Title: Inspection of Rotor head		
AG-SB-2022-09-B-ENR2	Effective Date: 07.10.2022	Compliance Category: A – MANDATORY B – RECOMMENDED C – OPTIONAL
Applicability		
Aircraft type & model: All Cavalon and Calidus with Rotor head III	Affected Serial number(s): All Cavalon and Calidus with Rotor head III	
The maintenance manual to be referenced is this stated or subsequent issue.		As per AutoGyro website
This form is the response from AutoGyro GmbH either against a problem found in the product in service requiring a containment or rectification action, or as service information for aircraft modification incorporation. For help, contact airworthiness@auto-gyro.com .

The purpose of this SB is to highlight the need for effective pre-flight and service inspection of the weld that joins the rotor head side plate to the roll link bracket.

Rotorhead III

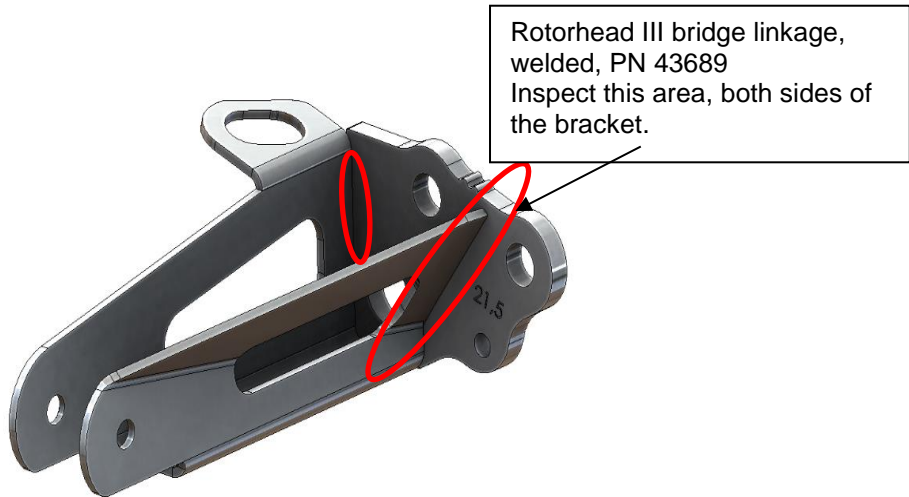
Pre-flight inspection requires a thorough review of the rotorhead. Pilot/operators are reminded that this includes the welded connection between the side plates and roll link bracket shown below. This area is open for easy inspection.

The ringed area indicates the installed bridge linkage

If a crack is found, the part is to be replaced in accordance with normal maintenance procedures.

External weld with crack:

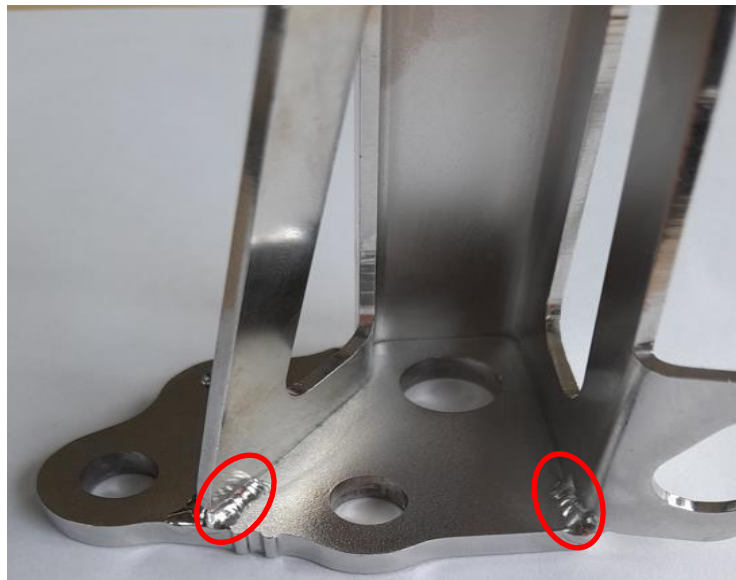
This area is readily inspected during pre-flight inspection

There are two generations of the Rotorhead III Rotor head bridge roll linkage assemblies. The second generation is welded on the inside upper end of the bracket, see photo, and was released in 2019. Only this later generation is available, and is fully interchangeable with the earlier version.

Note: these assemblies are stamped with the size (21.5 and 22.5). If replacing, ensure that the correct size is fitted!
